HISTORIC AND DESIGN REVIEW COMMISSION

HDRC CASE NO: 2025-001
ADDRESS: 362 E HUISACHE AVE
LEGAL DESCRIPTION: NCB 3088 BLK 4 LOT 15
ZONING: R-4, H
CITY COUNCIL DIST.: 1
DISTRICT: Monte Vista Historic District
APPLICANT: Anthony Chen/Aeonium Investments LLC
OWNER: BEAM GREGORY & ALISON
TYPE OF WORK: Final Approval - Garage/ADU
APPLICATION RECEIVED: December 30, 2024
60-DAY REVIEW: February 28, 2025
CASE MANAGER: Bryan Morales
REQUEST:

The applicant is requesting approval to construct an approximately 360 sf detached rear accessory structure.

A-2
ELEVATION'S

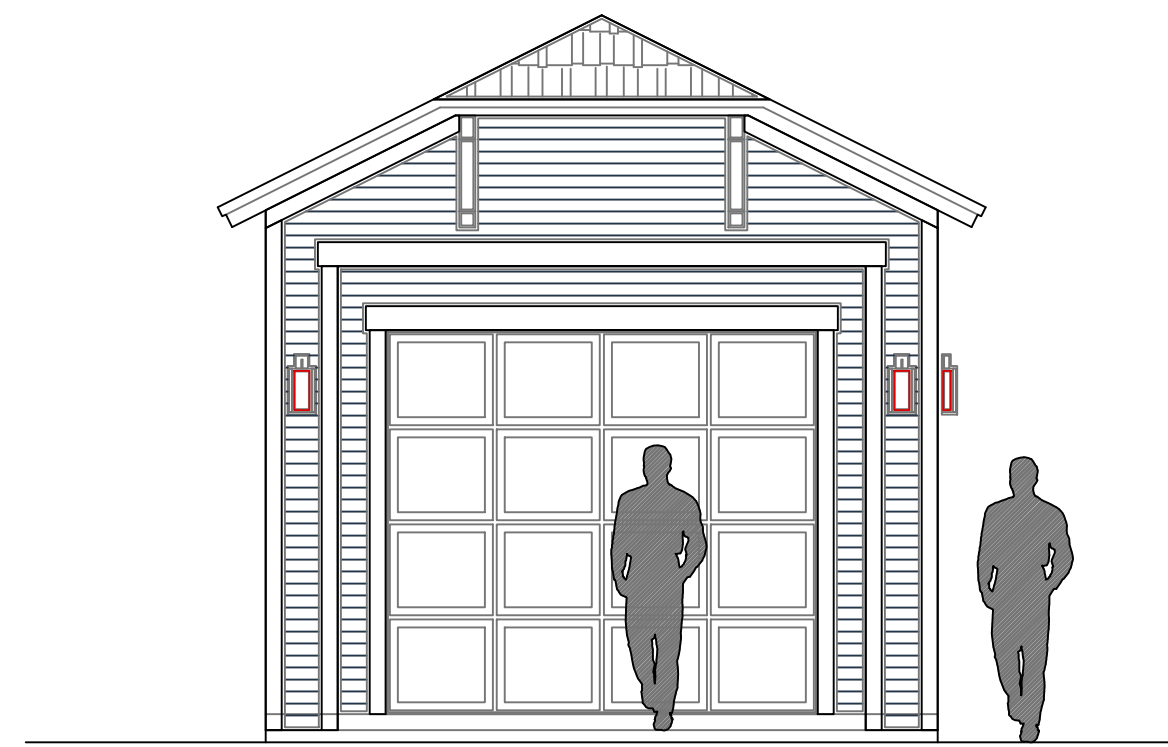
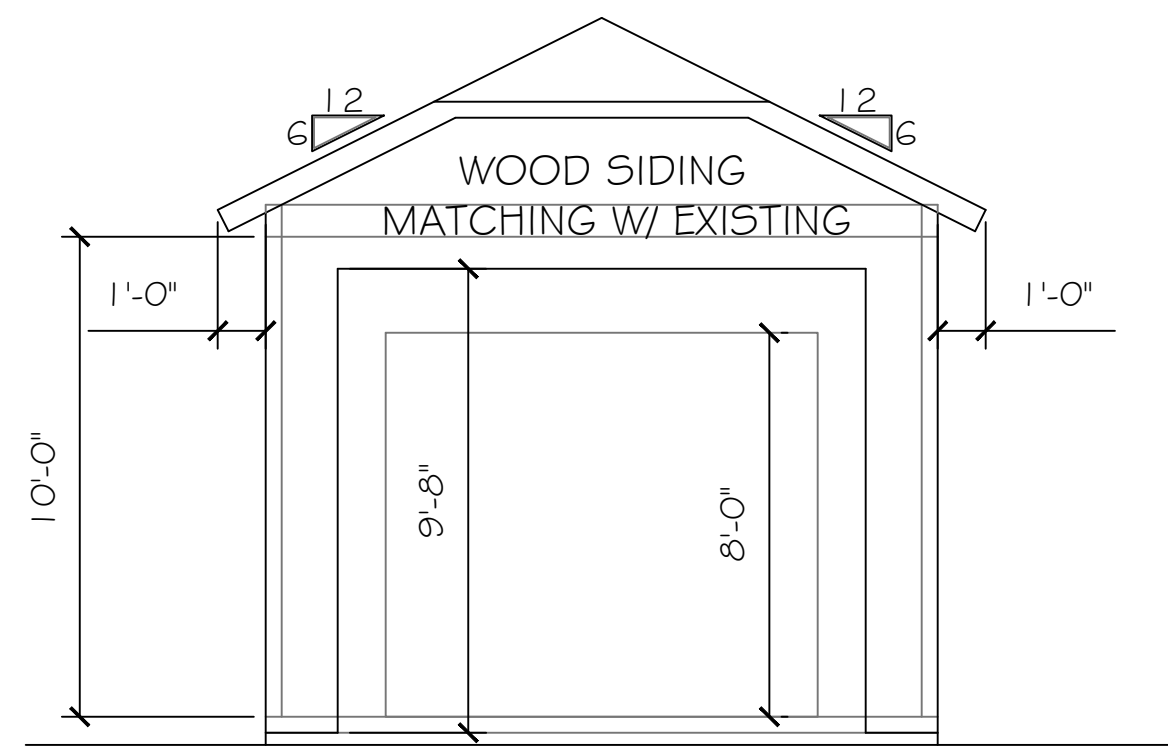
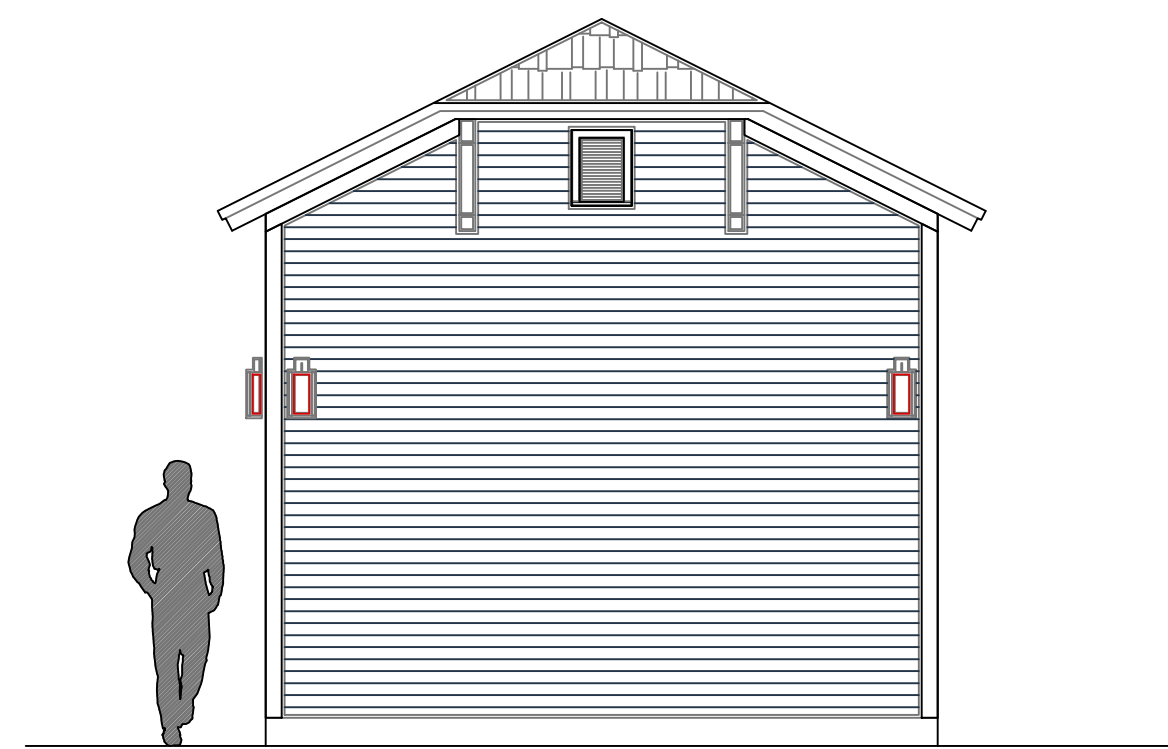
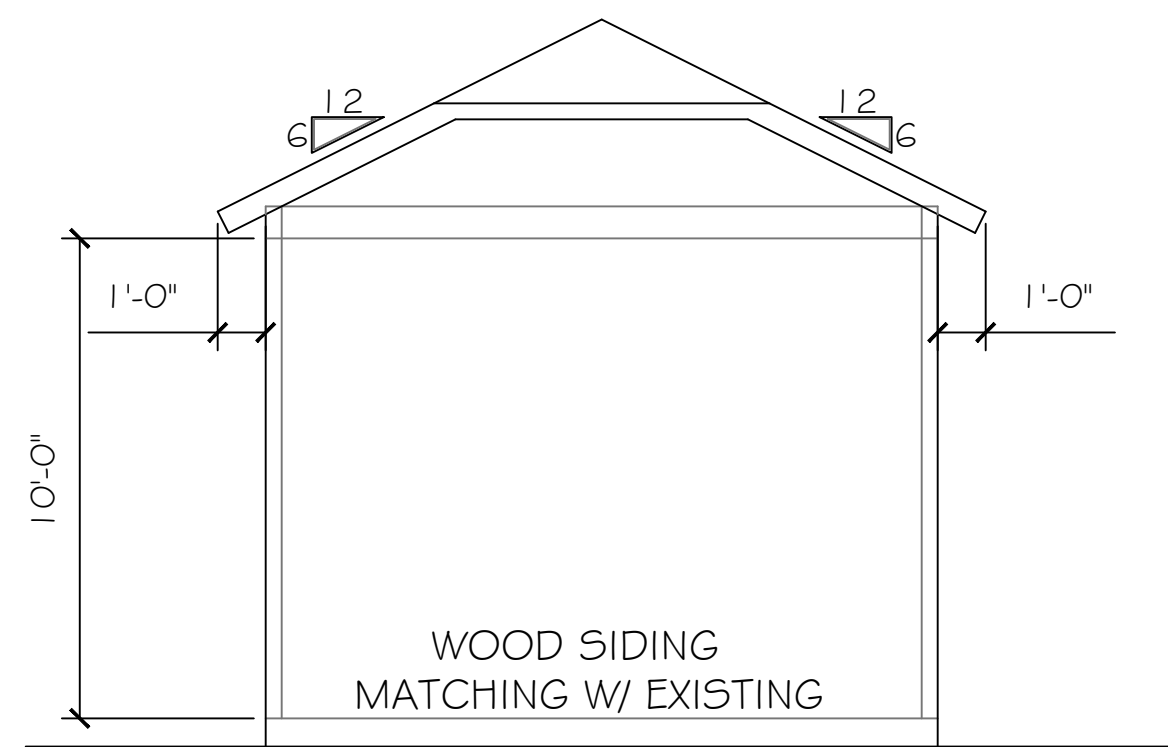
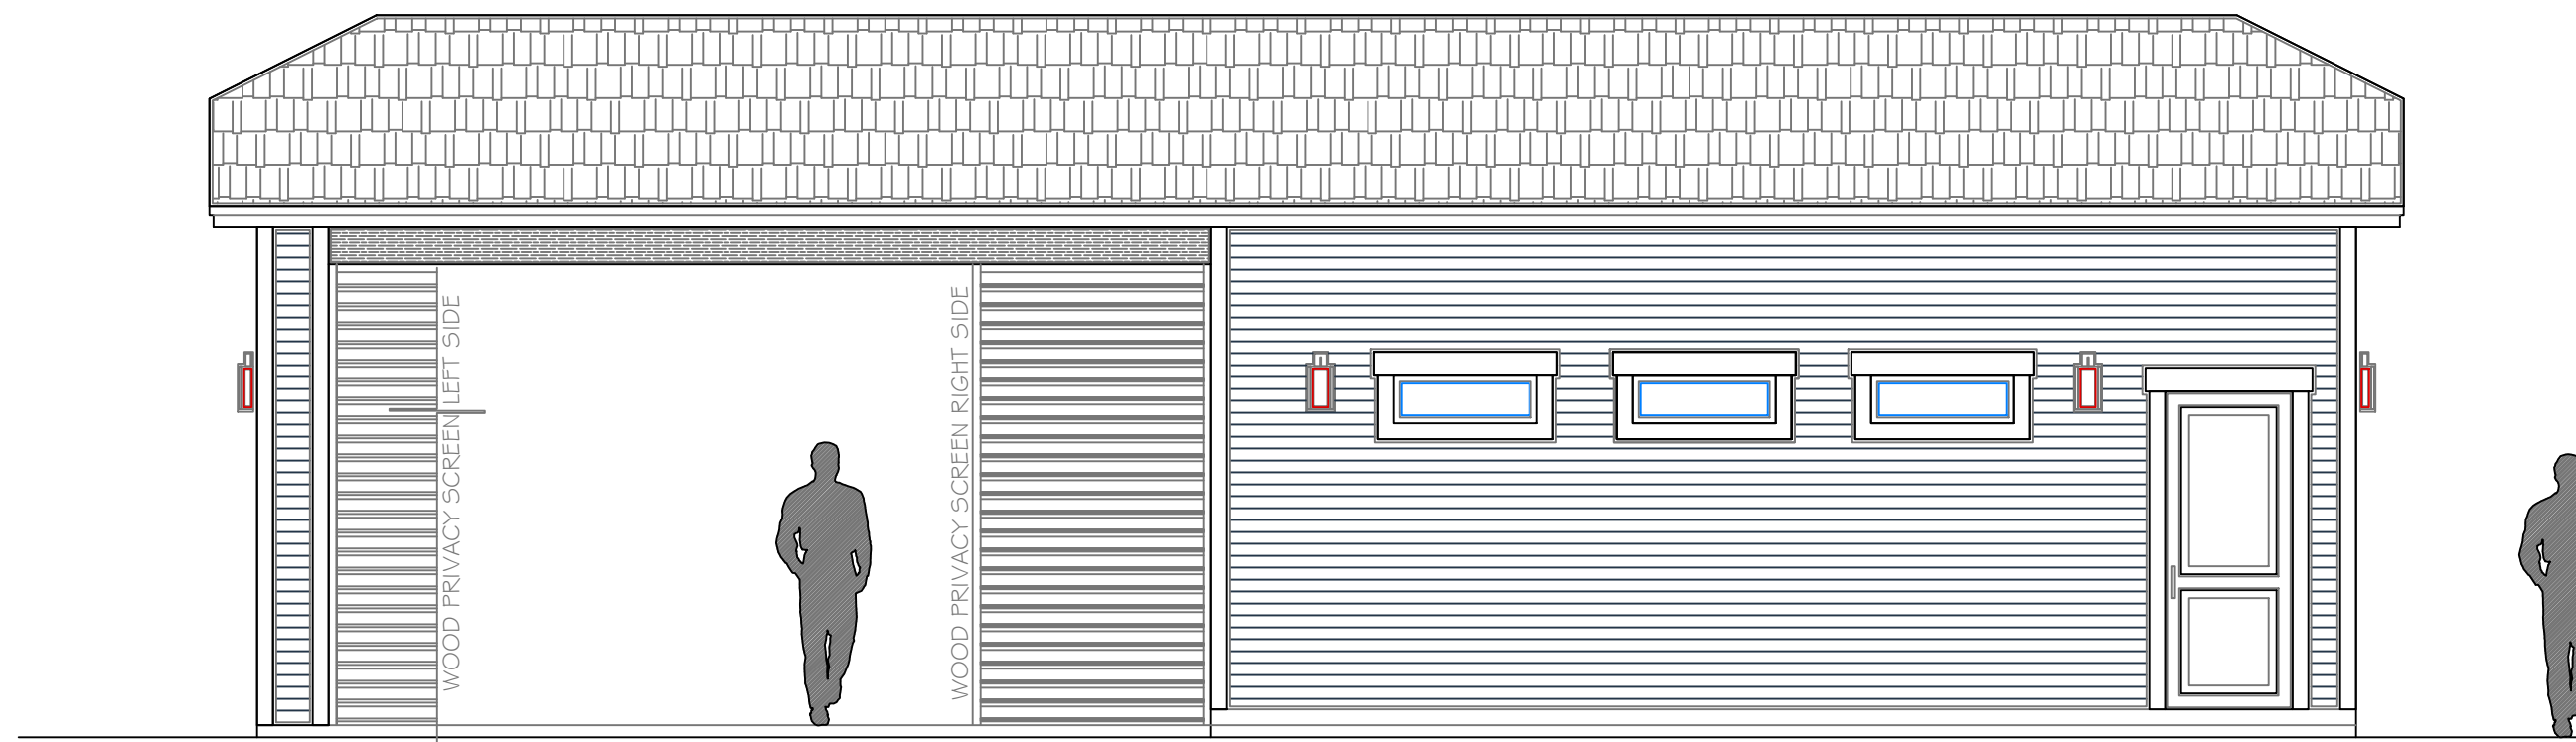
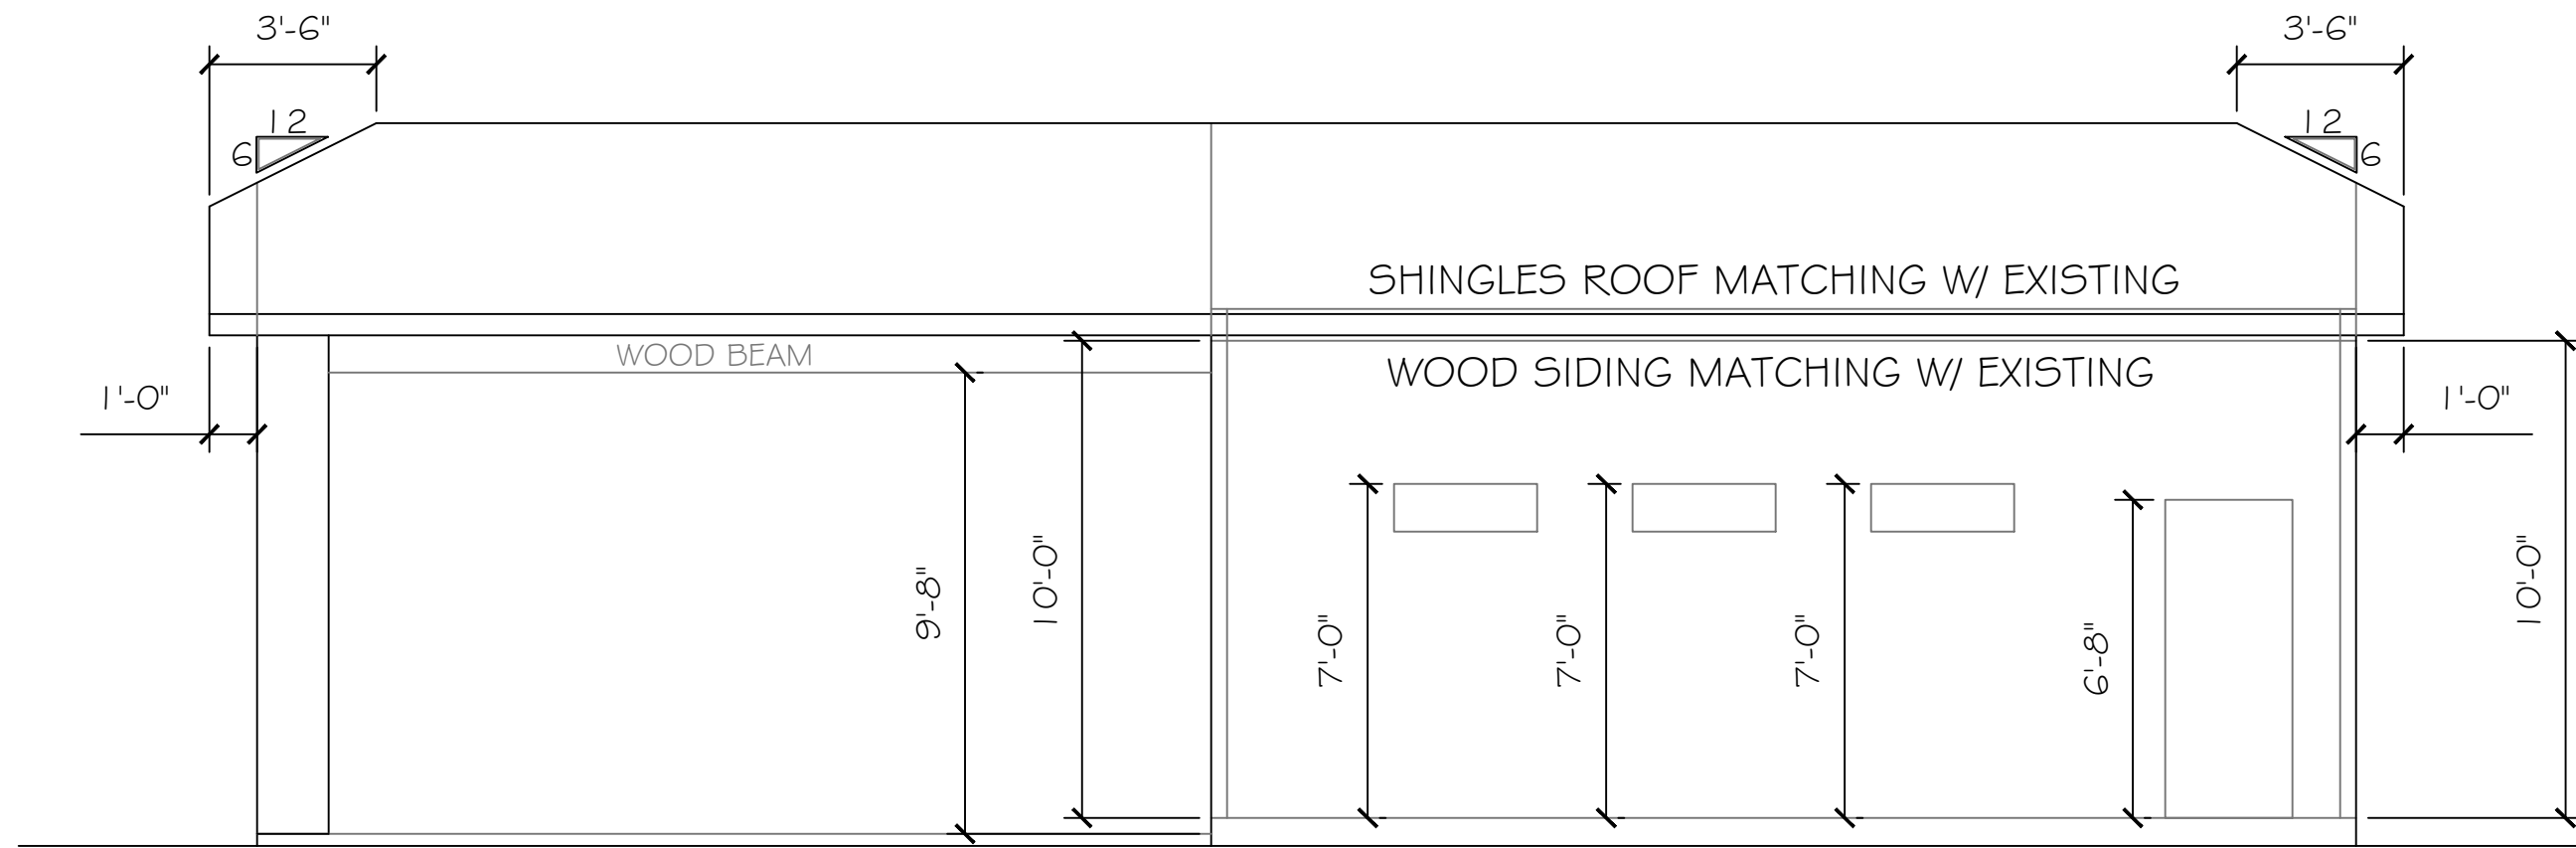
- e. ARCHITECTURAL DETAILS – The applicant is requesting approval to construct a 1-story accessory structure at the rear of the property featuring a roof vent, Craftsman roof brackets, and louvered wood wall sections. The Guidelines for New Construction 5.A.iii. and 5.A.iv. note that new accessory structures should relate to the period of construction of the primary historic structure on the lot by using complementary materials and simplified architectural details. Staff finds the roof vent, roof brackets, and louvered wood wall sections generally appropriate.

- f. ARCHITECTURAL DETAILS (MATERIALS) – The applicant is requesting approval to construct a 1-story accessory structure at the rear of the property with a composition shingle roof and 117 wood siding. The Guidelines for New Construction 5.A.iii. and 5.A.iv. note that new accessory structures should relate to the period of construction of the primary historic structure on the lot by using complementary materials and simplified architectural details. Staff finds the proposed composition shingle roof generally conforms to Guidelines. Staff finds the installation of 117 wood siding generally conforms to Guidelines. New Construction 2.B.i states that roof

forms—pitch, overhangs, and orientation—consistent with those predominately found on the block should be incorporated. Staff finds the proposed hip-on-gable roof and its pitch conforms to Guidelines.

- g. ARCHITECTURAL DETAILS (FENESTRATION PATTERN) – The applicant is proposing to install one Craftsman wood door on the right façade, one garage door on the front façade, and three rectangular windows on the right façade. The Guidelines for New Construction 2.C.i. related to window and door openings stipulates to incorporate window and door openings with a similar proportion of wall to window space as typical with nearby historic facades. Staff finds the proposed fenestration pattern generally appropriate. The applicant has noted they will match the rectangular windows located on the historic primary structure.

- i. That the applicant meets all setback standards as required by city zoning and obtain a variance from the Board of Adjustment if applicable.
